Access Compliance Report

Public Rights-of-Way

(Curb Ramps)

Intersection ID: 9379	Main Street: BODKIN_CT	Cross Street: UPSALL_CT	Location:	N
ADA ID: 73720C020F41	Ramp Type: Perp	Initial Pass/Fail: Fail	Overall Compliance: No	Severity Score: 8.75
Codes/Mitigation Info/Possible Solution		Field Measurements/Component Compliance

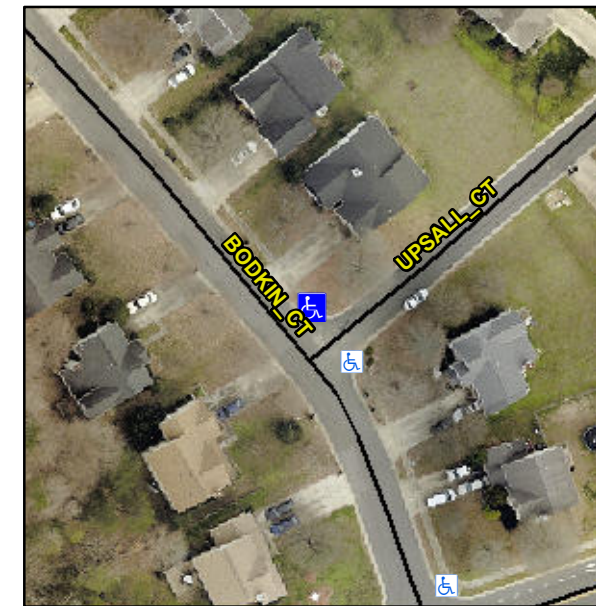
R304.5.1

Compliance	Description	Data	Compliance	Description	Data
N/A	Ramp Length (in)	52.0	Yes	Ramp Slope (%)	6.6
No	Ramp Width (in)	47.0	Yes	Ramp XSlope (%)	1.6
N/A	Flare Type LT	N/A	N/A	Flare Type RT	N/A
N/A	Flare Slope LT (%)	N/A	N/A	Flare Slope RT (%)	N/A
N/A	Flare Traversable LT?	N/A	N/A	Flare Traversable RT?	N/A
N/A	Landing Length (in)	N/A	N/A	DWS Provided?	N/A
N/A	Landing Width (in)	N/A	N/A	DWS Contrast?	N/A
N/A	Landing Slope (%)	N/A	N/A	DWS Length (in)	N/A
N/A	Landing X Slope (%)	N/A	N/A	DWS Full Width?	N/A
N/A	Landing Curb? (Y/N)	N/A	N/A	DWS Offset (in)	N/A
N/A	Shared Landing?	N/A			
N/A	Gutter Ponding?	N/A	N/A	Gutter Slope (%)	N/A
N/A	Gutter Lip Ht (in)	N/A	N/A	Gutter X Slope (%)	N/A
N/A	Painted X Walk1?	No	N/A	Painted X Walk2?	N/A
	X Walk 1 Direction	To S		X Walk 2 Direction	N/A
N/A	X Walk 1 Width (in)	N/A	N/A	X Walk 2 Width (in)	N/A
	X Walk 1 Slope (%)	3.0		X Walk 2 Slope (%)	N/A
	X Walk 1 X Slope (%)	0.1		X Walk 2 X Slope (%)	N/A

Remove & Replace Entire Ramp.
